# Product Change Notification

**Overview:** Please be advised that the following is notice of change to the Fire Research SoBrite mounting yoke.

**Products Affected:** All SRA100 Yoke Mount models.

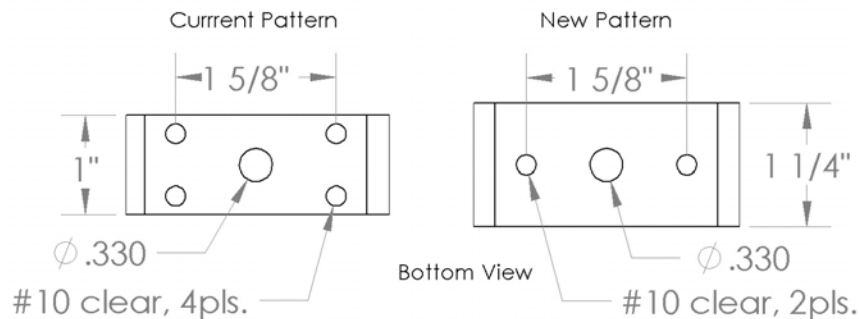
**Change Description:** Effective February 1<sup>st</sup> 2016, the mounting pattern yoke for the above SoBrite models will change from the 5-hole pattern to a 3-hole pattern as illustrated below. The overall width will increase to 1 1/4" from the current 1". The overall height of the SoBrite with the yoke attached will remain the same.

**Reason for Change:** A wider mounting surface area for better stability, and a reduced number of mounting holes ensures quicker and easier installation.
